Staff Report

Tentative Partition Plat, Site Plan Review for Tree Felling, and Site Plan Review for New Construction

PA-05-24; SP-08-24; & SP-09-24

May 28, 2024

EXISTING CONDITIONS/DEMO PLAN
 TENTATIVE PARTITION
 MAP 115-3W-8CC
 TAX LOT 900
 ALBANY, OREGON

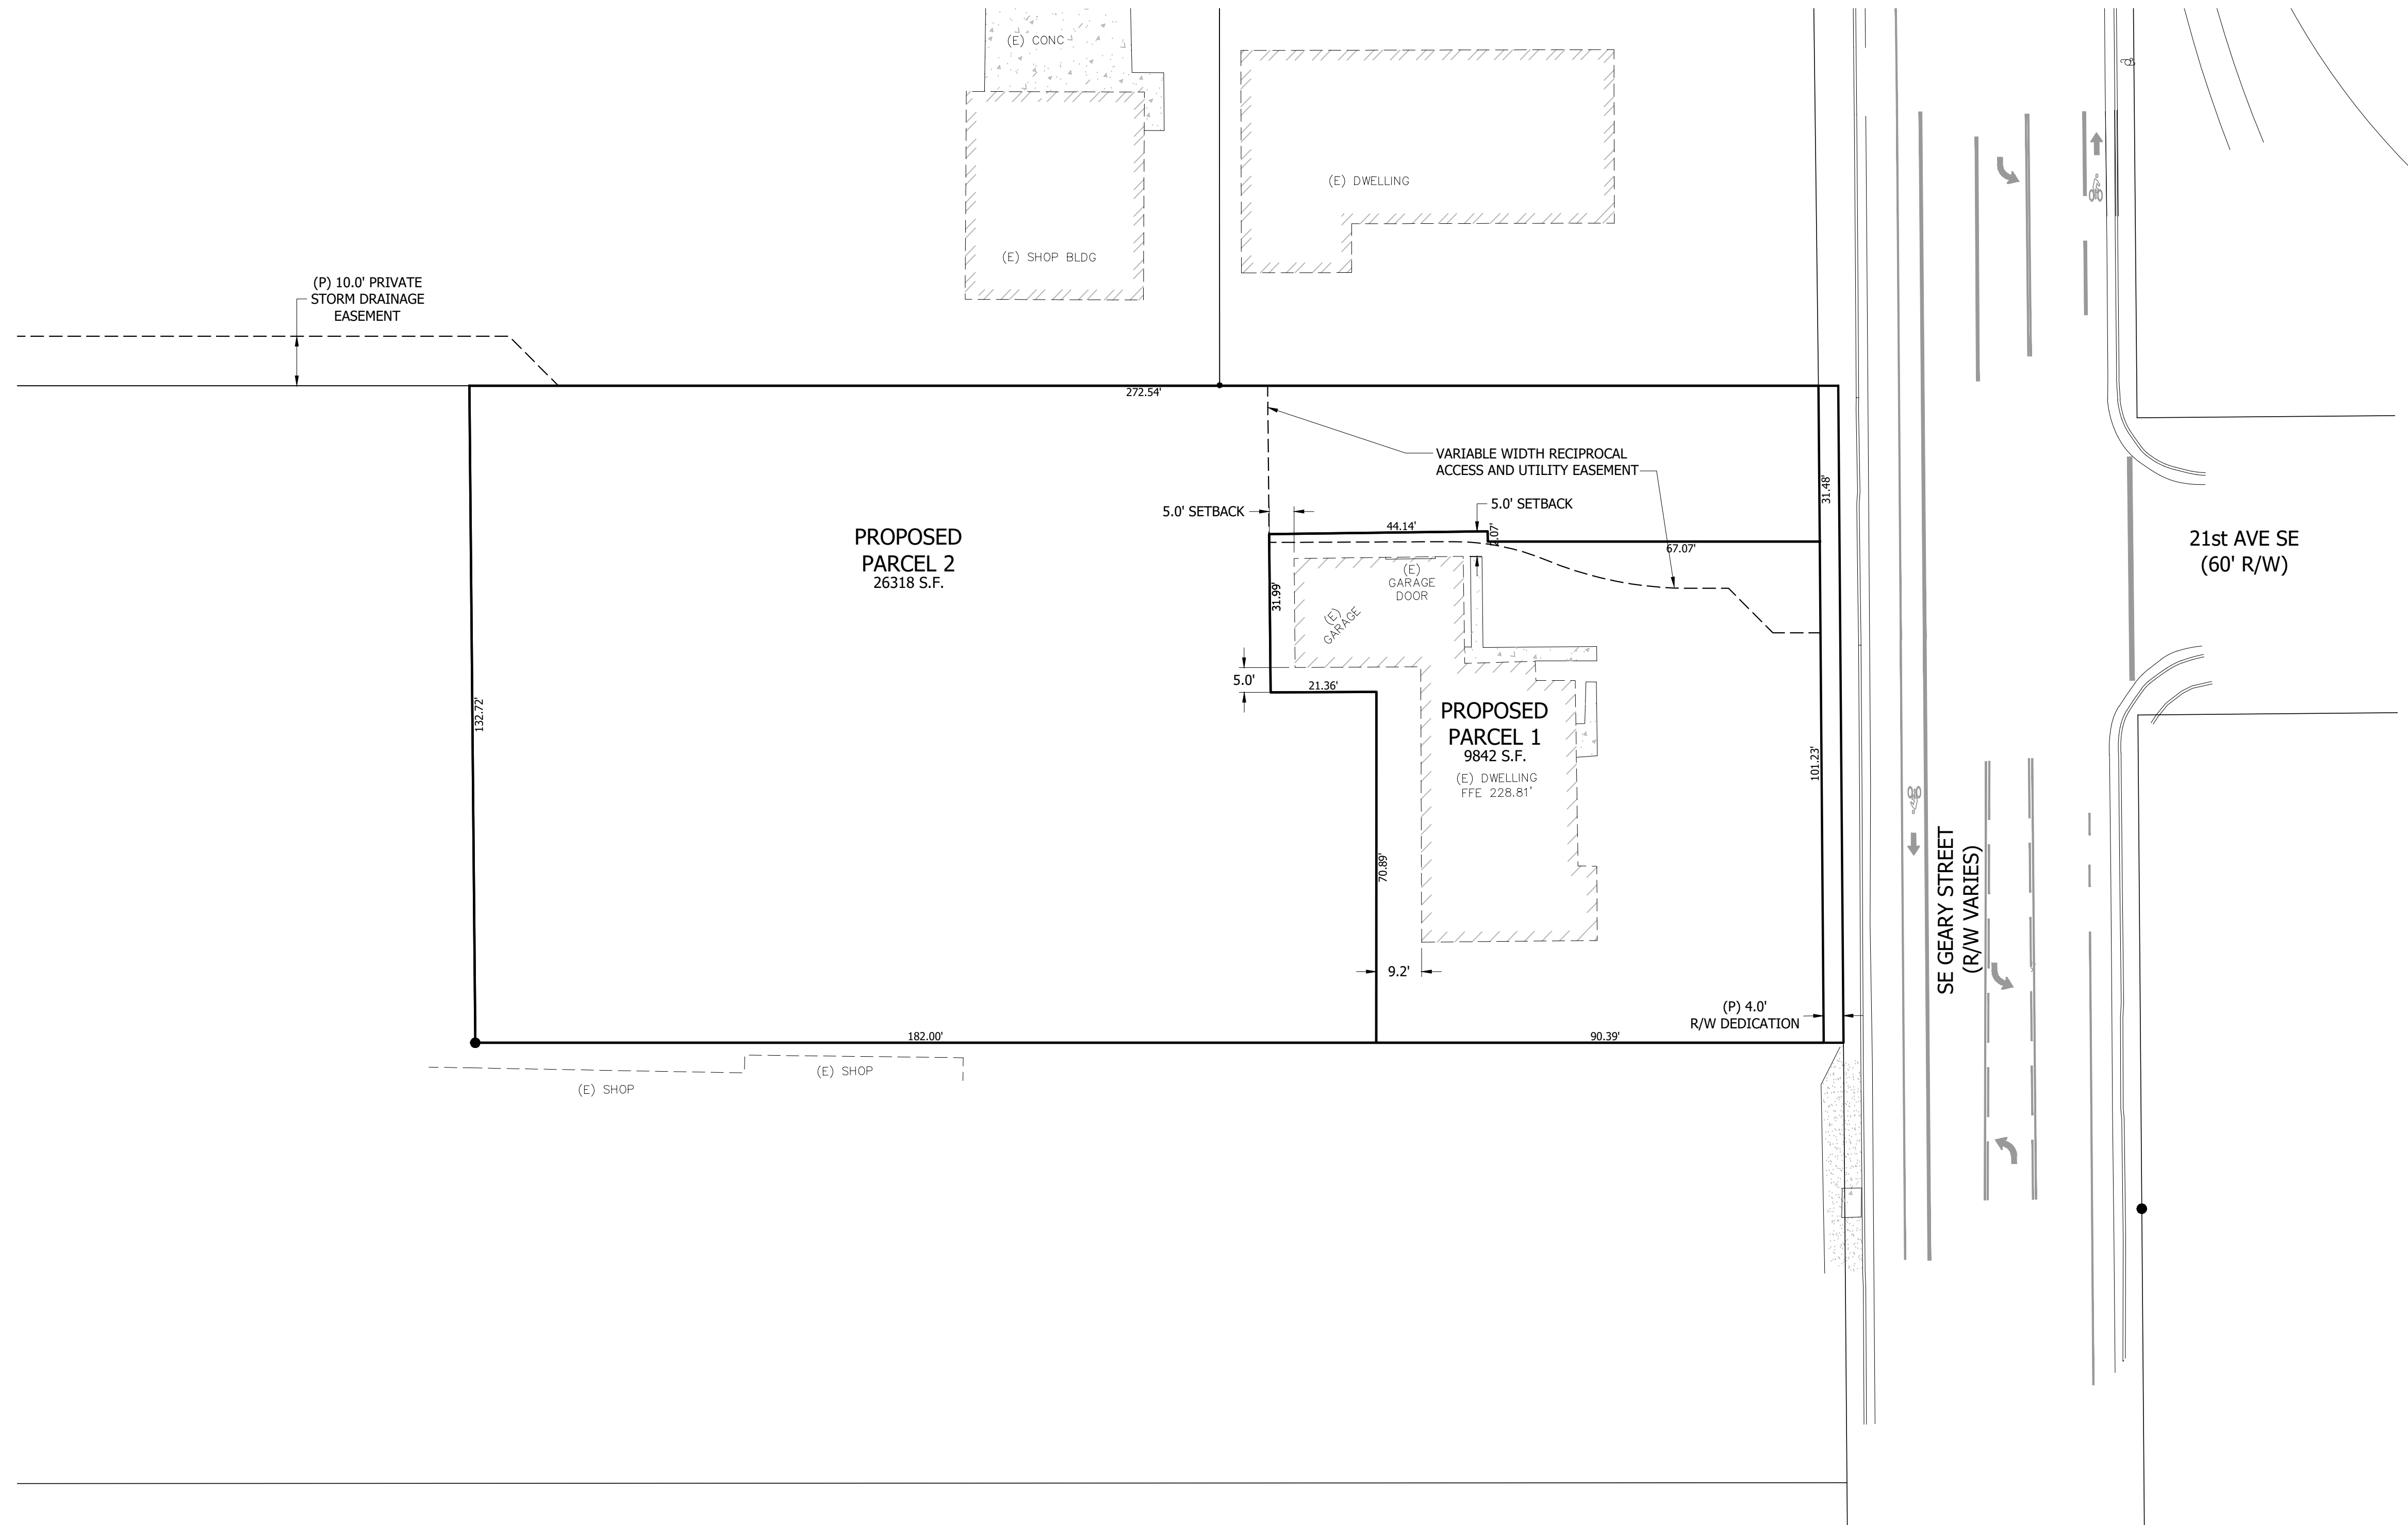
Condition 7 In the event the proposed development does not take place, the trees identified for removal on the Existing Conditions Plan (Attachment B.1) shall not be removed without separate approval for tree felling not associated with development, using criteria listed in ADC 9.205(3).

PRELIMINARY CIVIL SITE PLAN
 TENTATIVE PARTITION
 MAP 11S-3W-8CC
 TAX LOT 900
 ALBANY, OREGON

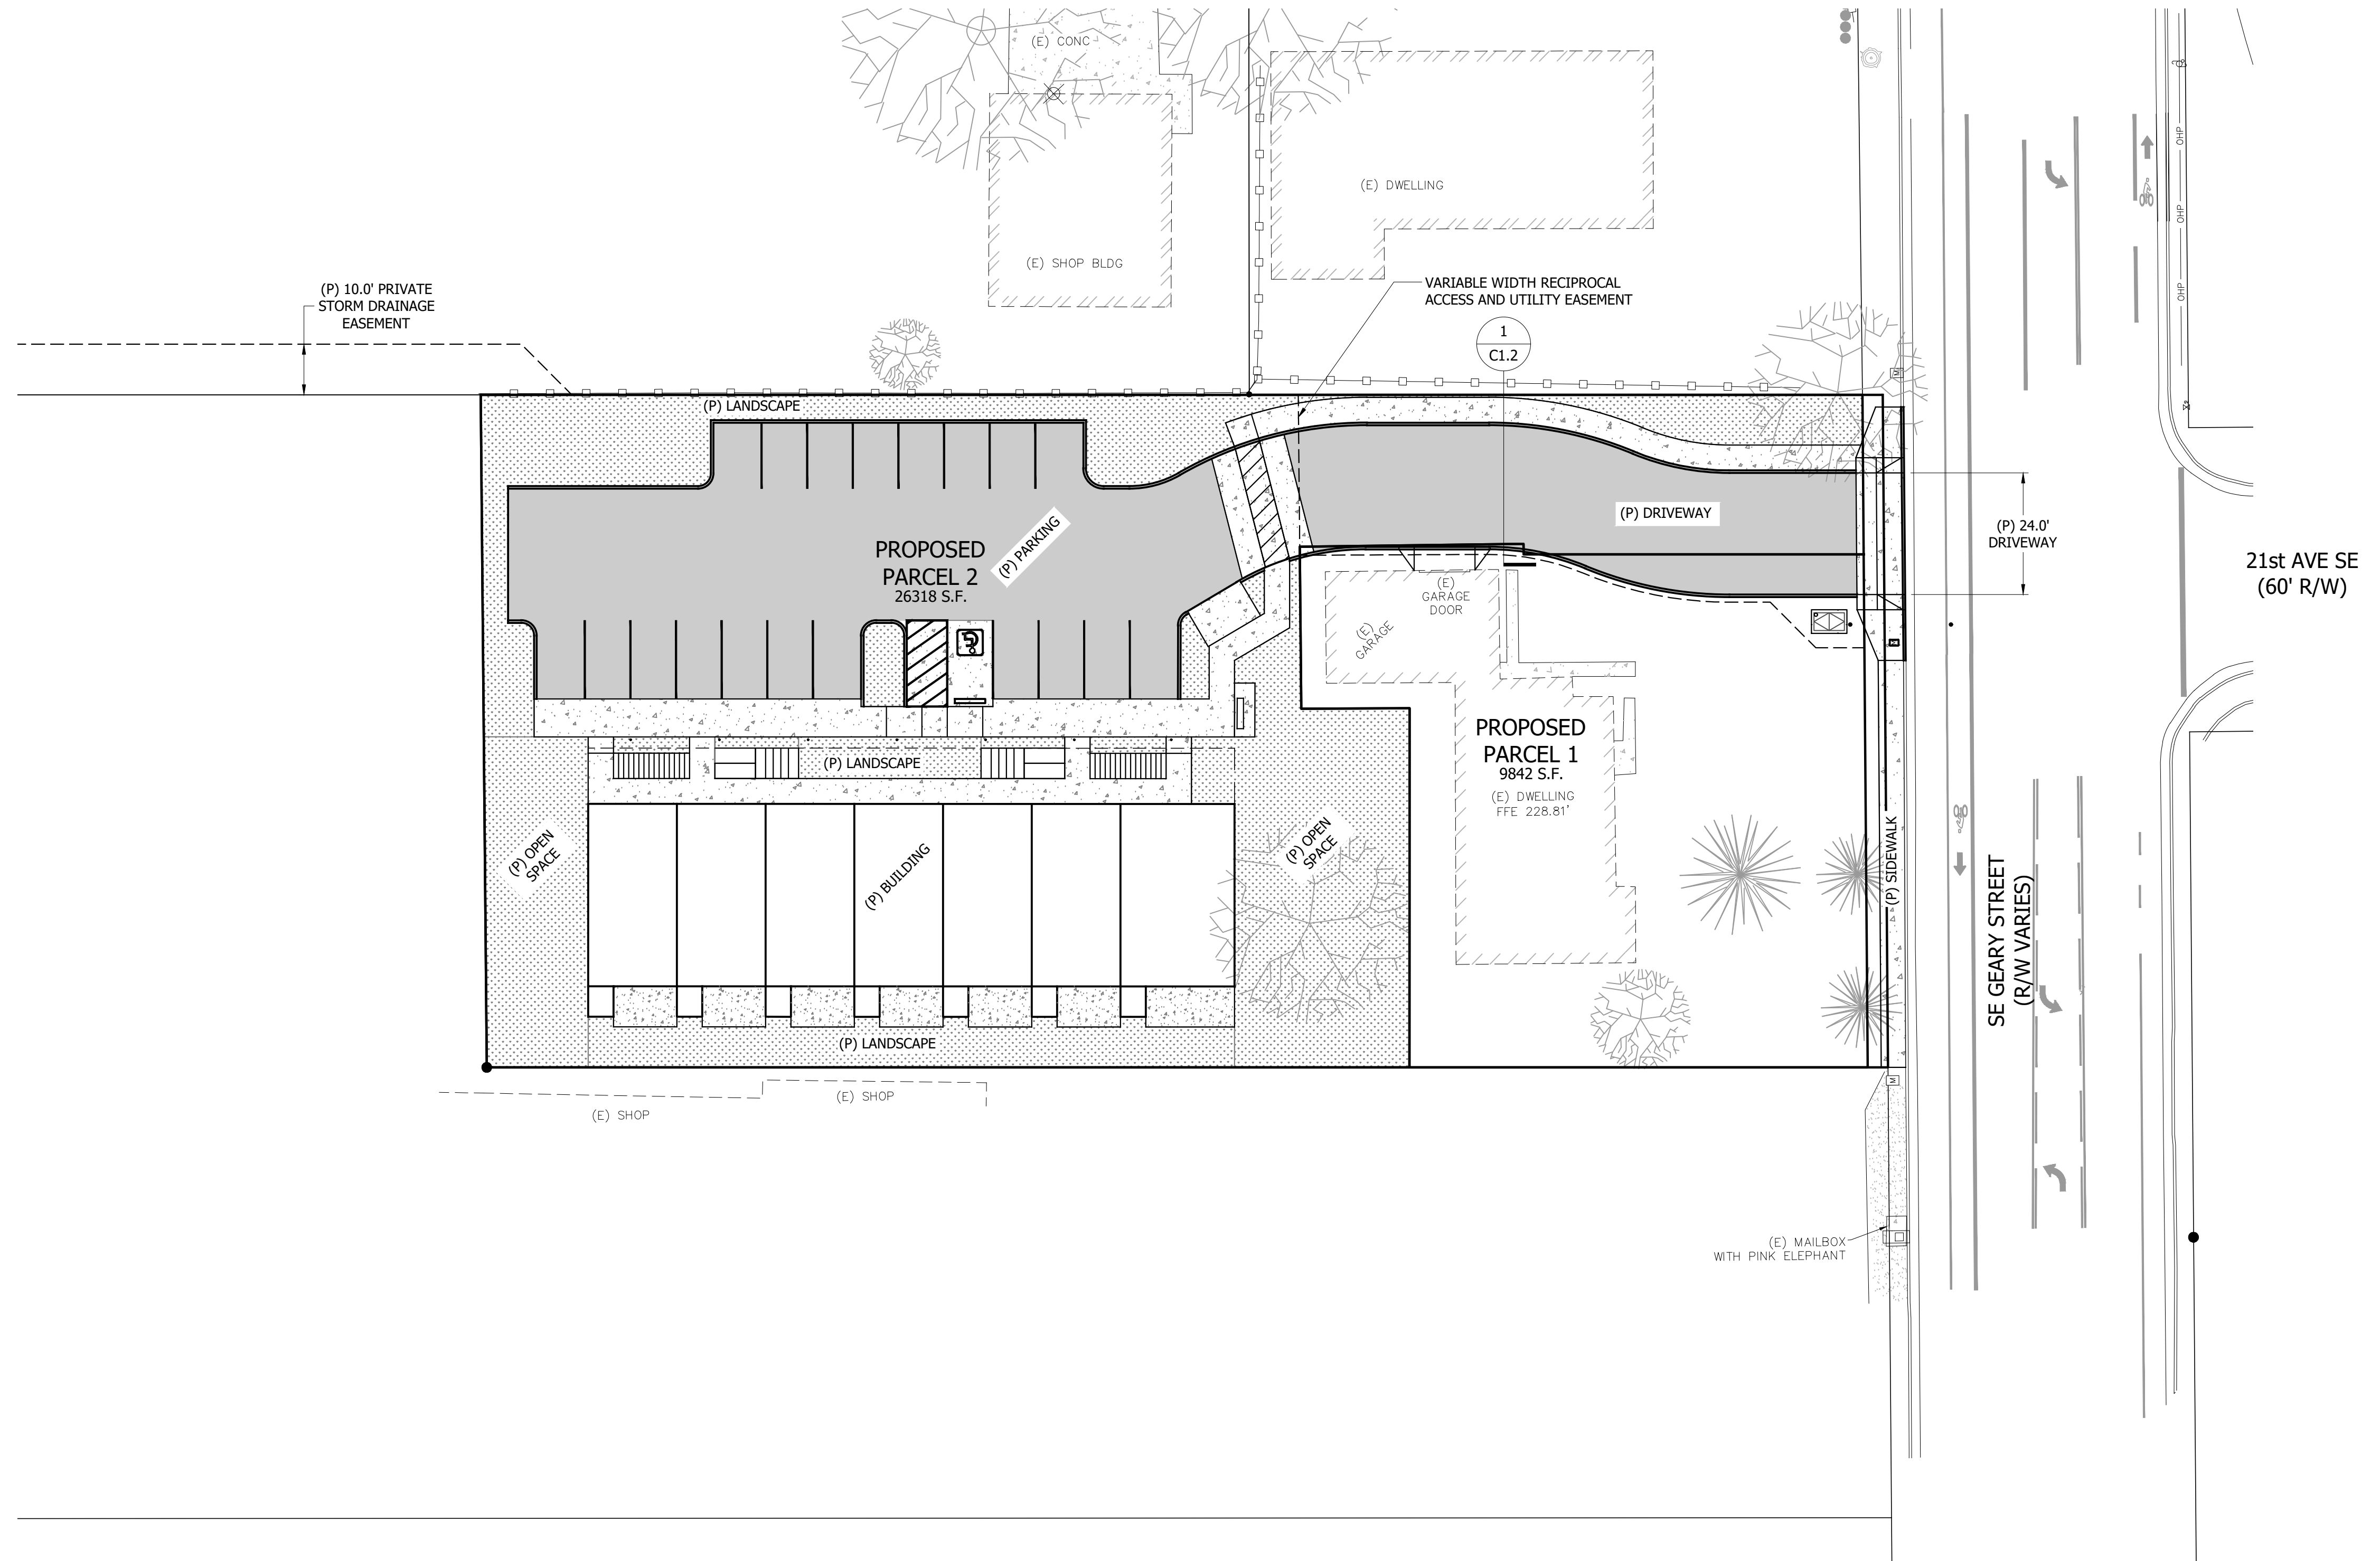
The applicant's site plan (Attachment B) shows a total of 2,973 square feet of common space is provided on the site. 1,968 square feet (66 percent) of the common open space is identified as common open space lawn with a bench. The applicant also proposes a 1,005 square-foot garden area for residents. Per ADC 8.220(2)(a)(iii), this amenity may not account for more than 50 percent of the required common open space and the gardens must have irrigation available for use by the residents. As a condition of approval, the applicant shall be required to show the location of irrigation for the garden on an updated site plan at time of building permit, with installation of the irrigation required prior to issuance of final Certificate of Occupancy.

Condition 10 Common Open Space. Before the acceptance of a building permit, the applicant shall provide an updated site plan showing the location of irrigation for the garden. Prior to issuance of the final Certificate of Occupancy, the irrigation shall be installed.

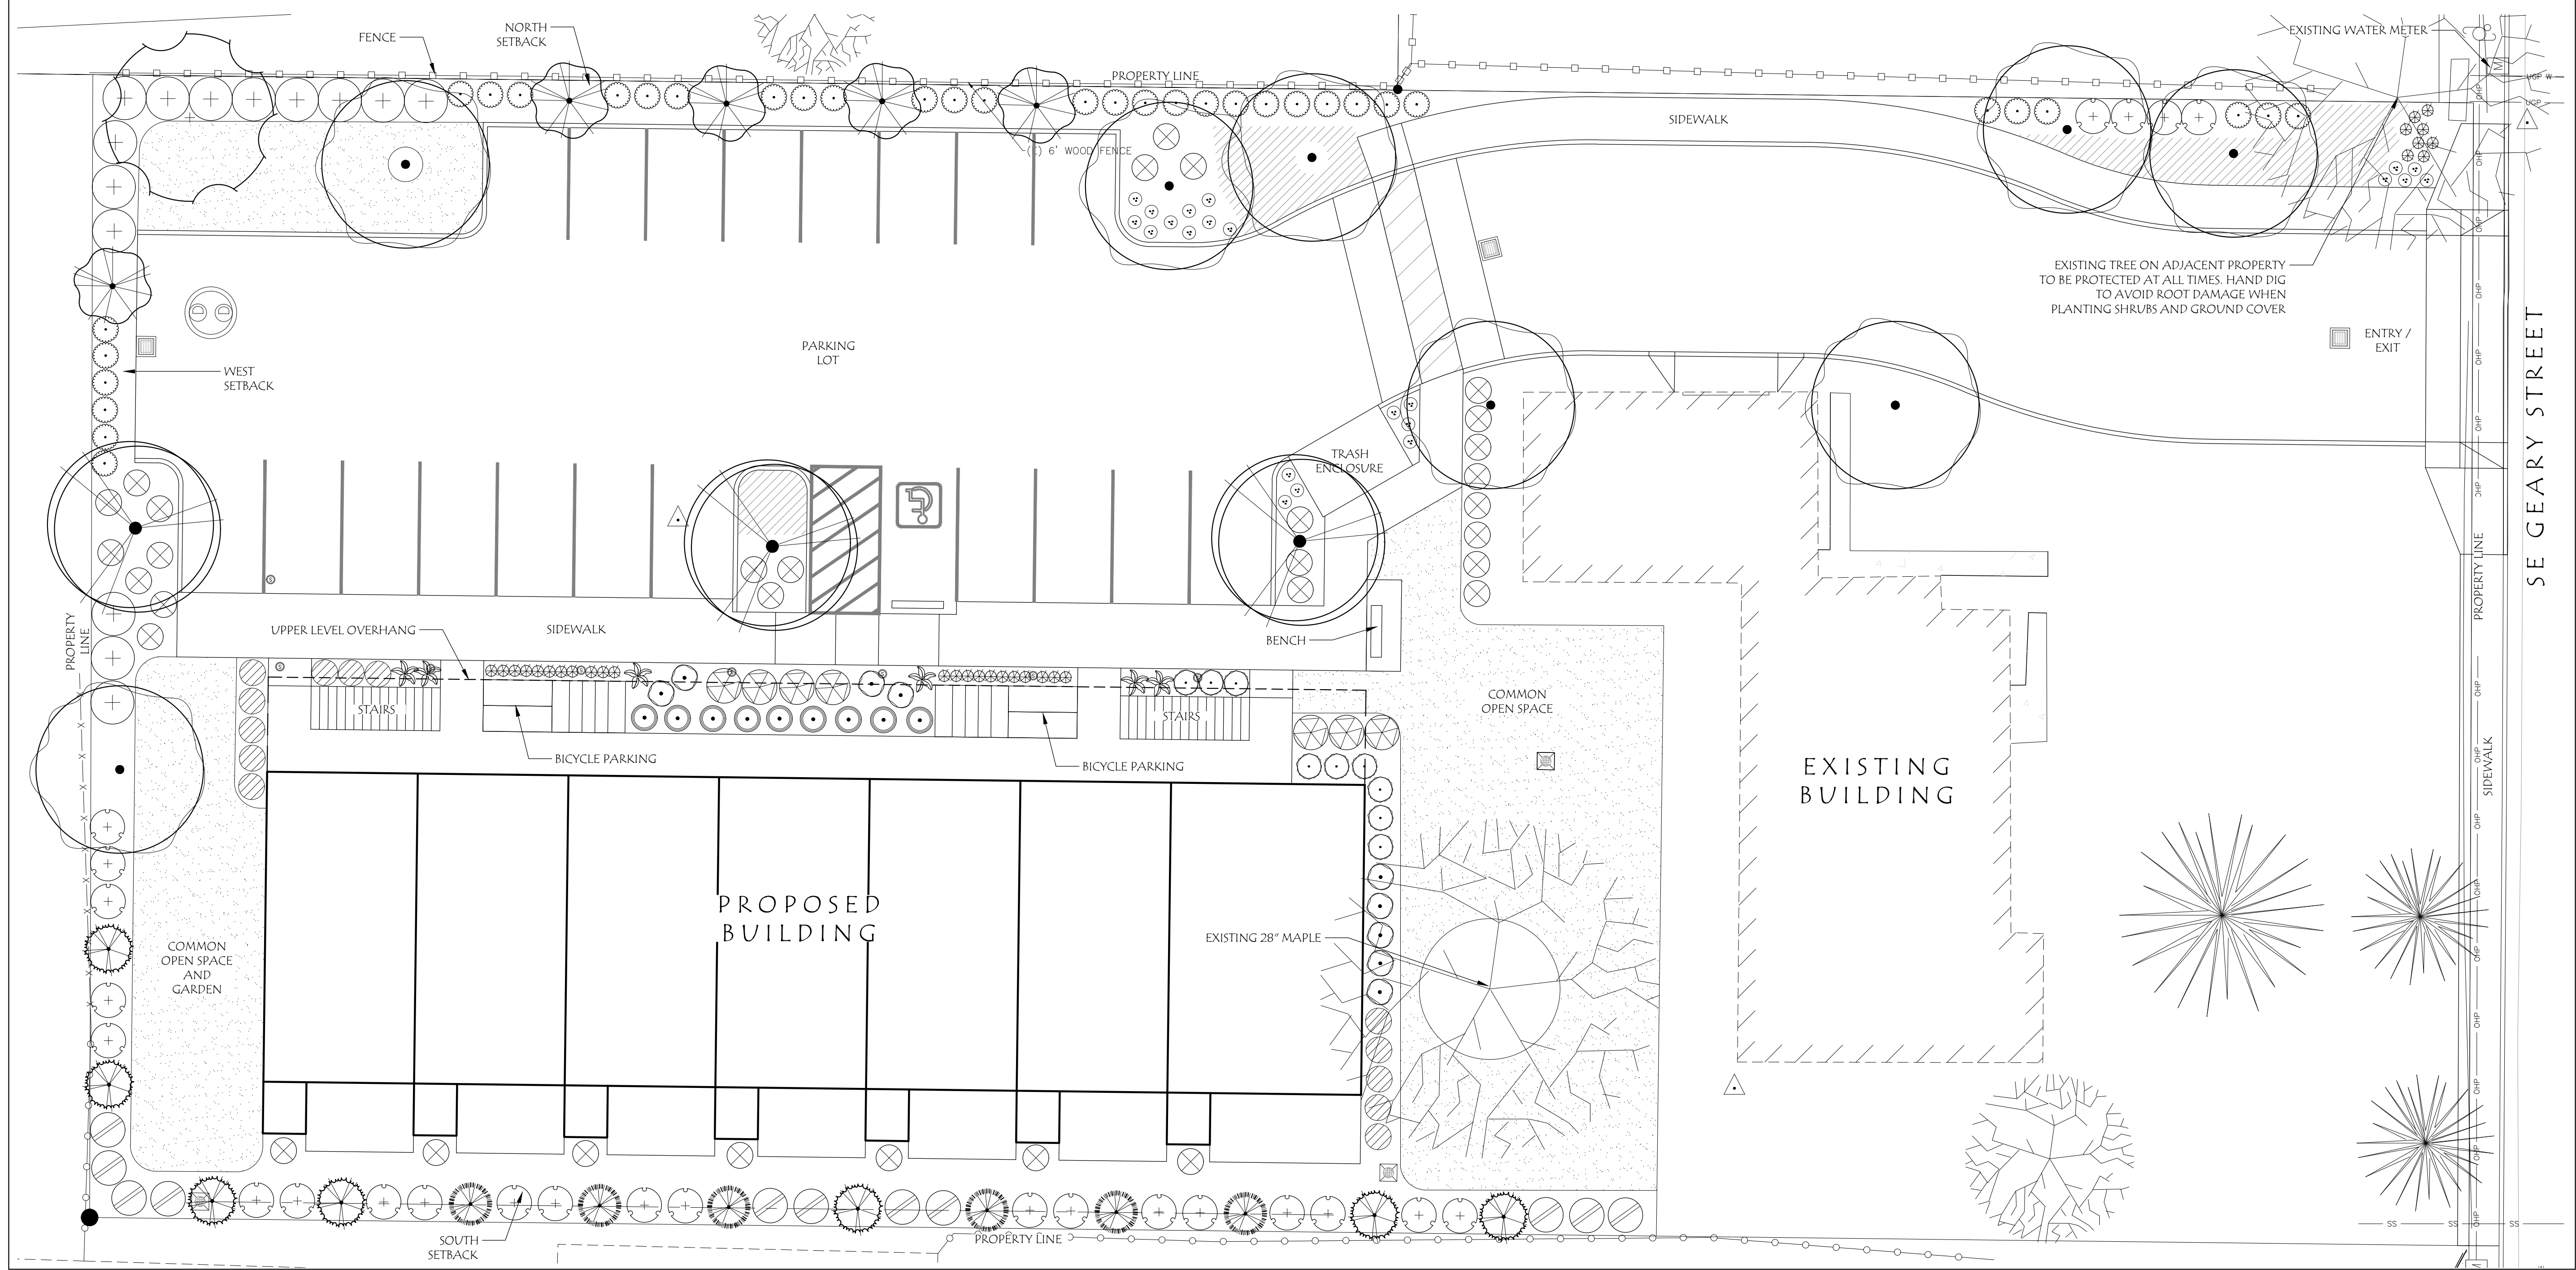
The subject property has 275 linear feet along the north property line which equates to 2,750 square feet of required landscaped buffer area. Thus, the landscaping requirement along the west property line are as follows: 9 deciduous trees at least ten feet tall or 18 evergreen trees at least five feet tall, 10 five-gallon shrubs or 20 one-gallon shrubs, and the remaining area treated with groundcover. The applicant's site plan demonstrates that all areas, with the exception of where the pedestrian access is located, will be buffered (Attachment F.1).

The subject property has 98 linear feet along the east property line which equates to 980 square feet of required landscaped buffer area. Thus, the landscaping requirement along the east property line are as follows: 3 deciduous trees at least 10 feet tall or 6 evergreen trees at least 5 feet tall, 5 five-gallon shrubs or 10 one-gallon shrubs, and the remaining area treated with groundcover. The applicant does not indicate that any trees will be planted here, however shrubs are provided (Attachment F.1). As a condition of approval, the applicant shall be required to provide an updated landscaping plan indicating buffering on the east property line of Parcel 2.

Condition 13 Landscaping, Buffering, and Irrigation System. Before the City will accept any building permits for the proposed structure(s), the applicant shall provide a landscape plan, which shall include buffering along the east property line of Parcel 2 in conformance with ADC 9.240, and either an irrigation plan or a letter from a qualified landscape professional stating irrigation is not required per ADC 9.160.
